Planning Commission Vote Report

Meeting Date: February 13, 2023
From: Alyssa Ahner, Planner
Location: 14319 Olive Blvd
Description: P.Z. 04-2022 14319 Olive Blvd (Queathem House, LLC): A request for a zoning map amendment from a “NU” Non-Urban District with a Historic Overlay to a “PC” Planned Commercial District with a Historic Overlay for a 2-acre tract of land located north of Olive Blvd (16R310974).

RE: P.Z. 04-2022 Queatham House, LLC. (14319 Olive Blvd)

14319 OLIVE BLVD
PRELIMINARY DEVELOPMENT PLAN
SITE DEVELOPMENT PLAN

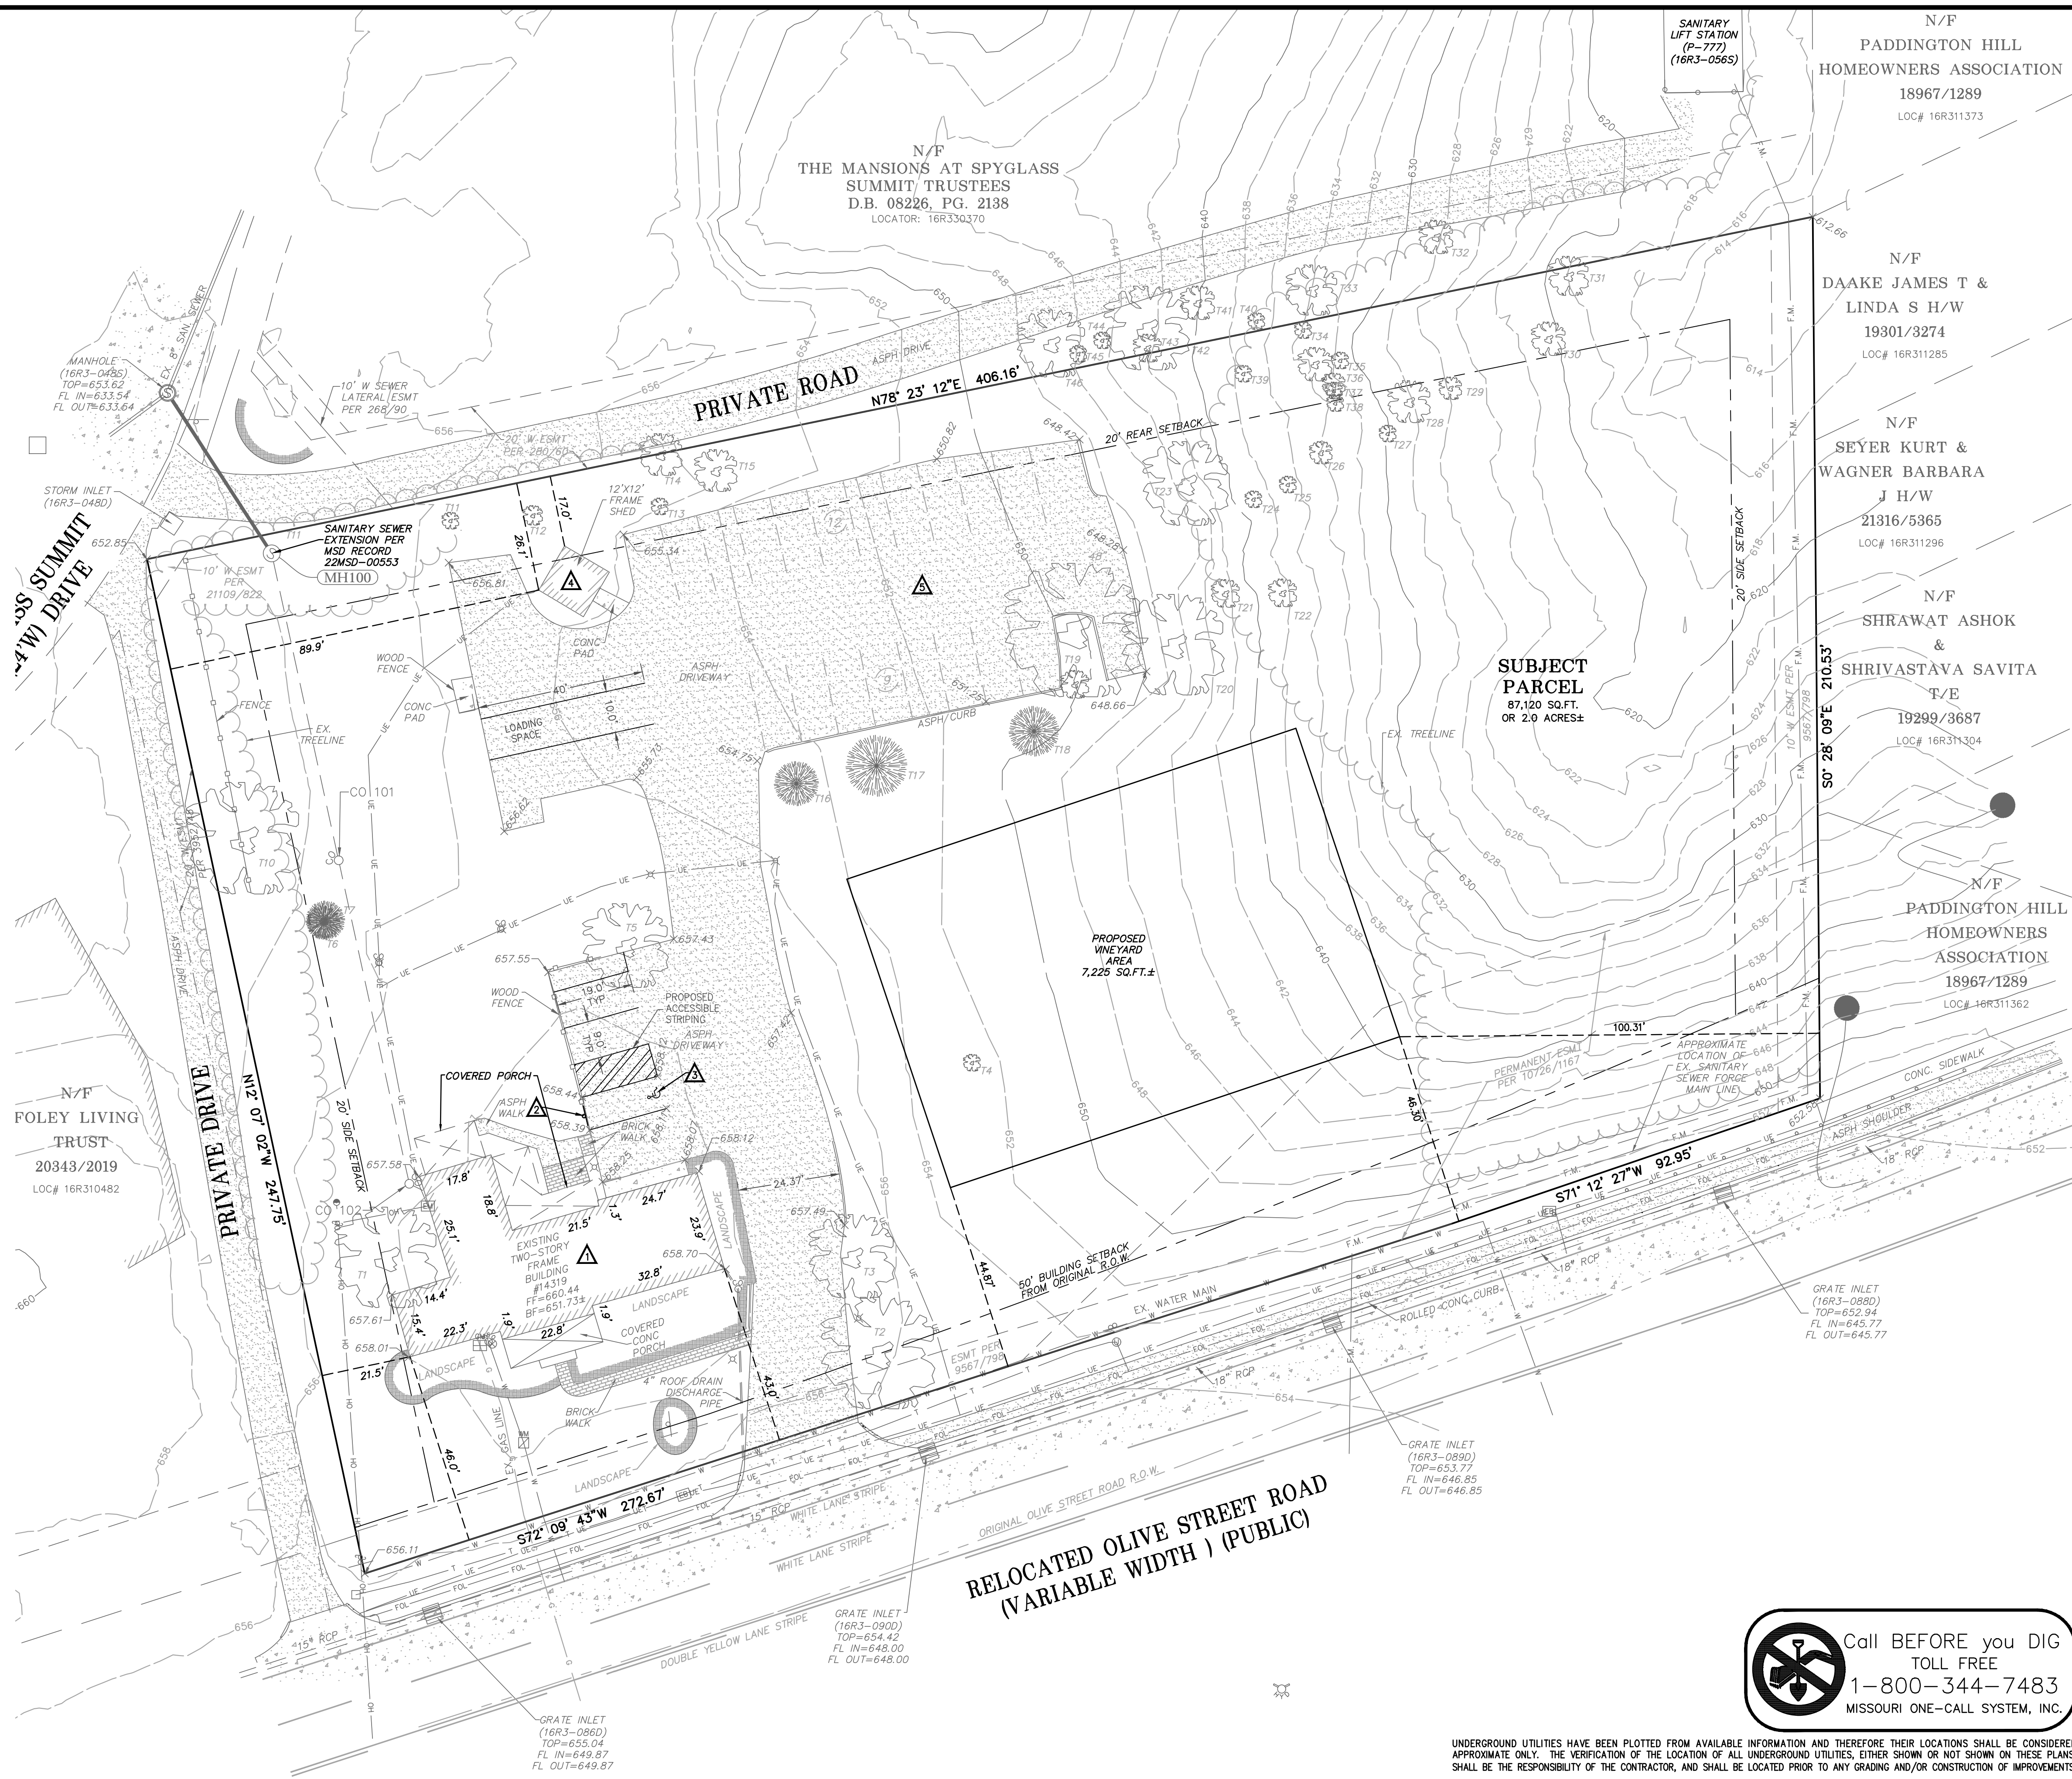
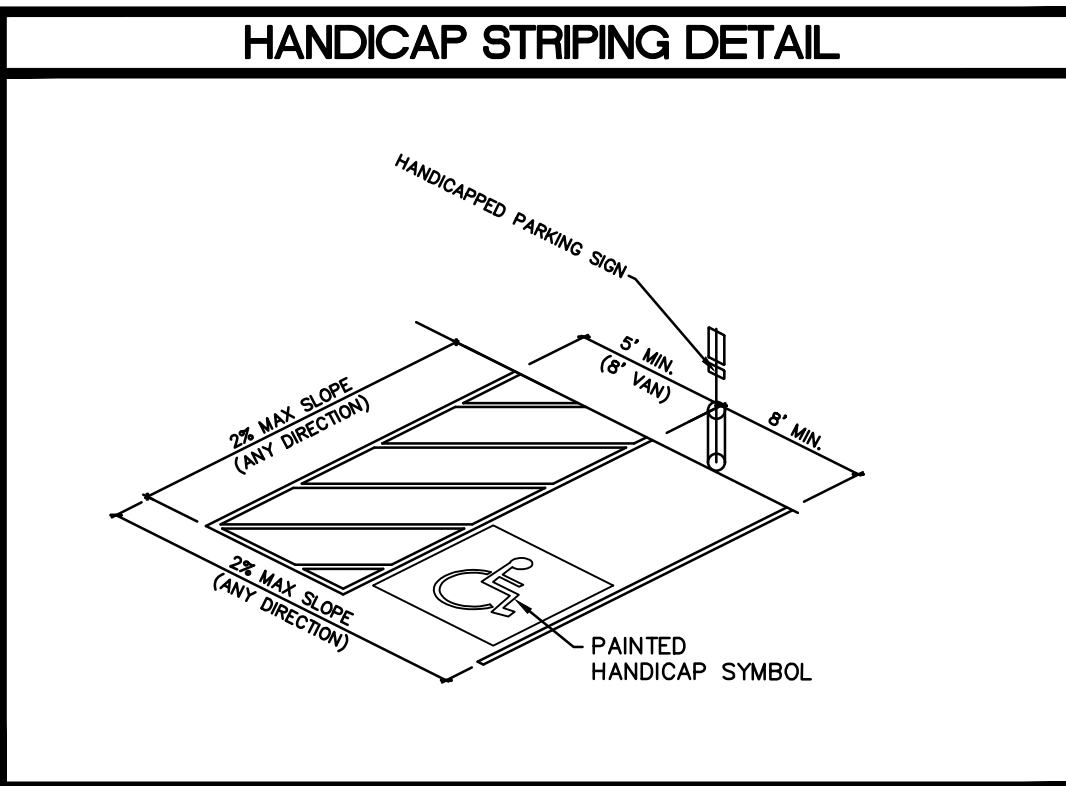
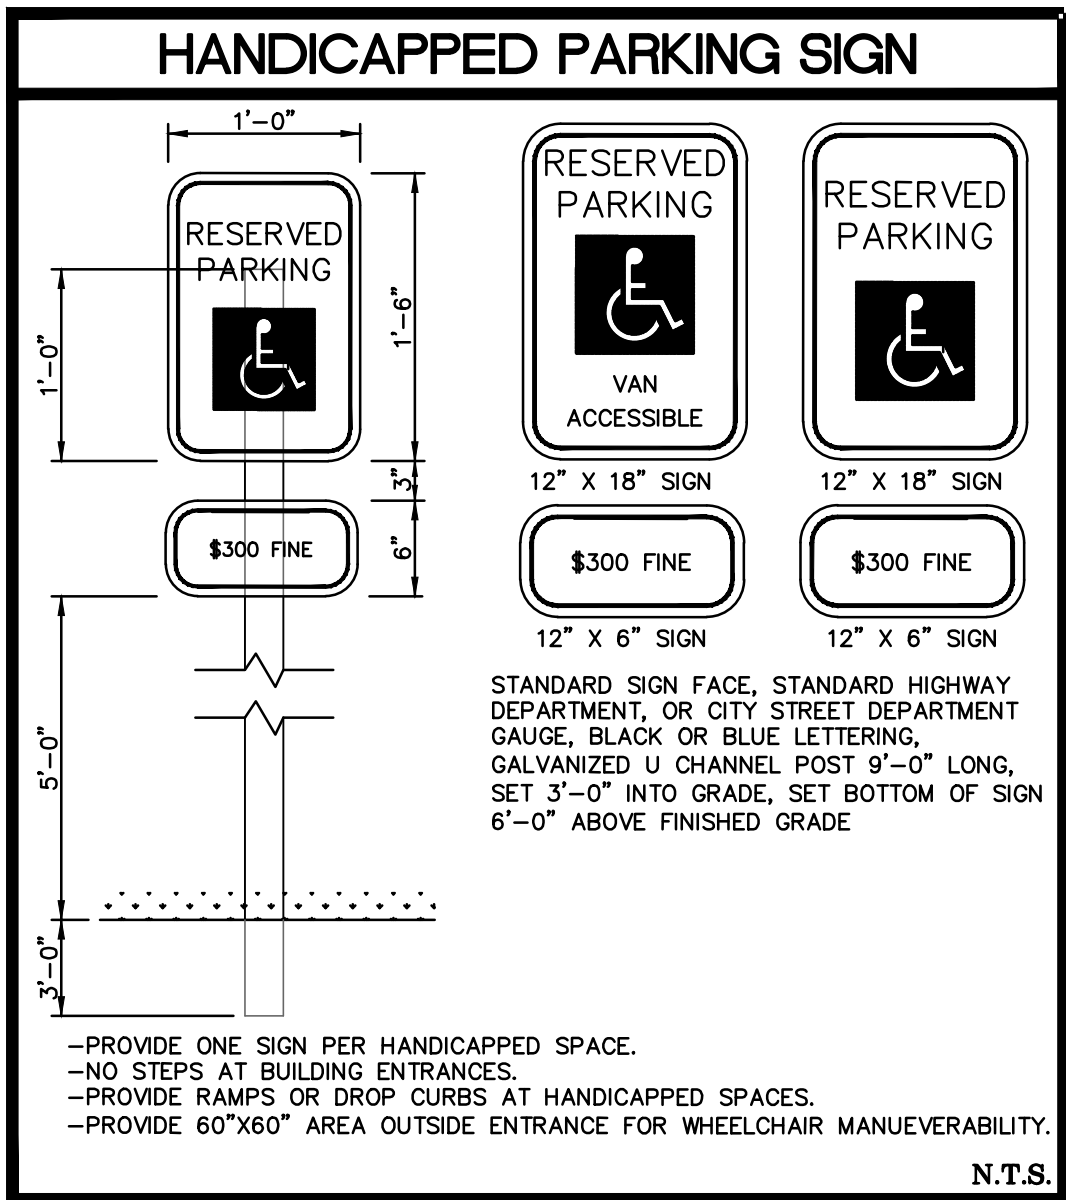
- 6) Provide a 5-foot-wide sidewalk, conforming to ADA standards, along the entire Olive Blvd. frontage of the site. The sidewalk shall provide for future connectivity to adjacent developments and/or roadway projects. The sidewalk may be located within right-of-way controlled by another agency, if permitted by that agency or on private property within a 6-foot-wide sidewalk, maintenance and utility easement dedicated for public use.
 - ▶ *DOT Purchased 20ft of setbacks – Sidewalk to go lot line to lot line, Parallel to Olive Blvd. -Date Unknown-*

- 7) A fence was installed along the northern property line; the fence location and height must be included on the preliminary development plan. Be advised, if the fence is taller than six (6) feet and located the in the property's setbacks, a clause must be written into the legislation to permit this.
 - ▶ There is not a fence that has been installed on northern property line. There are 9 fast growing evergreen trees that have been planted on the northern property line.

- 8) An outdoor patio was installed; the patio location and size must be included on the preliminary development plan.
- ▶ *We will get this added to preliminary development plan and submit. (60 ft. x 37.6 ft. from deck)*

- 9) Trees were removed; ensure the tree stand delineation that was provided to Staff reflects the current state of the property.
- ▶ *The only trees that were removed were because of MSD and new sewage. It is current with tree stand delineation that was provided to staff and does not reflect current state of property. If this was not done, a broken, backed up sewage line would have broken and caused tremendous damage to foundation and surrounding properties with raw sewage. (This IS in preliminary business plan plots. See attached)*
 - ▶ *There is more than 30% of property with shrubbery and trees which is more than required for property.*

- 10) The proposed parking setbacks reflect the location of the existing parking lot. Be advised, the proposed uses have individual minimum parking requirements. The proposed parking setbacks could hinder the ability to provide adequate parking for the proposed uses:
- a. Banquet facility: 3.3 per 1,000 Gross Floor Area
 - b. Restaurant, sit-down: 12 per 1,000 Gross Floor Area
 - c. Retail sales establishment, neighborhood: 4 per 1,000 Gross Floor Area

- ▶ The fence installed is on the west property line, this replaced the rotted fence that was in place.
- ▶ See *preliminary development plan (attached to email) page 4. tree delineation that states a fence. The fence is not taller than six (6) feet.*

► *The parking lot has been in existence for 30 years; it has been sealed and striped.*
